Mitchell Park Horticultural Conservatory Domes

May 16, 2017

Peer Review — Precast and Cladding

WJE Considerations for Enhancement

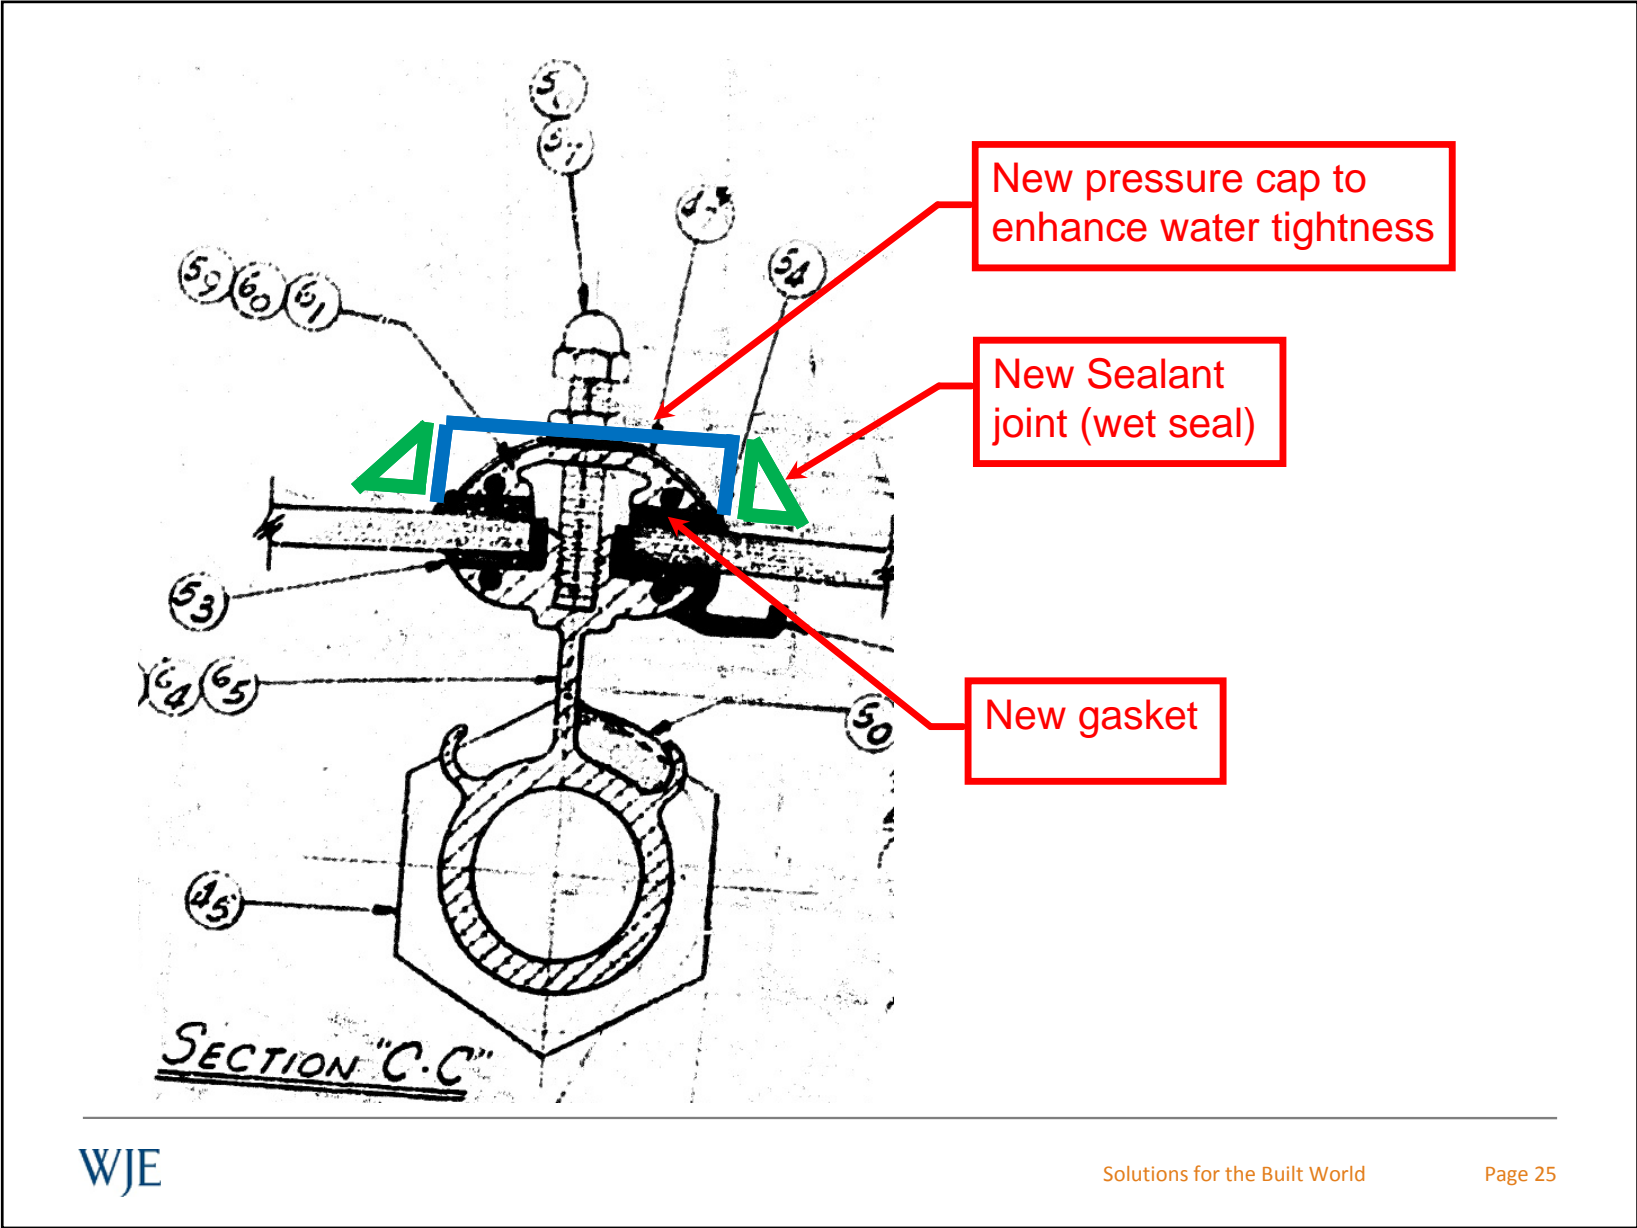
- Top-left callout:** GRAEF observed water sitting in the hub below this elevation, which is likely causing water leakage at fittings. A self-leveling sealant can be installed to fill in the "depressed" area (GRAEF repair).
- Top-right callout:** Water can then flow down the rafter at each hub and out at the base of the dome.
- Bottom-left callout:** At locations where leaks were observed, the rafter fitting had black material build-up (leak indicator). Target repairs could be performed.
